TI_2324: Adaptation of roll guide for iCombi Pro

iCombi Pro 6-1/1 - 10-2/1

30/10/2023

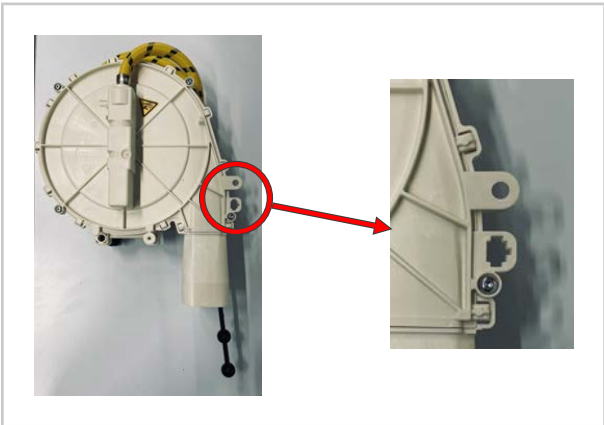
Due to the new option “Chemical storage system: iCareSystem AutoDose” the housing of the roll guide has been adapted. When servicing new devices that include the option “Chemical storage system: iCareSystem AutoDose” only new roll guides must be mounted. Only the new roll guides have a fixture for the cooling fan holder.

The service part number for the roll guide remains unchanged.
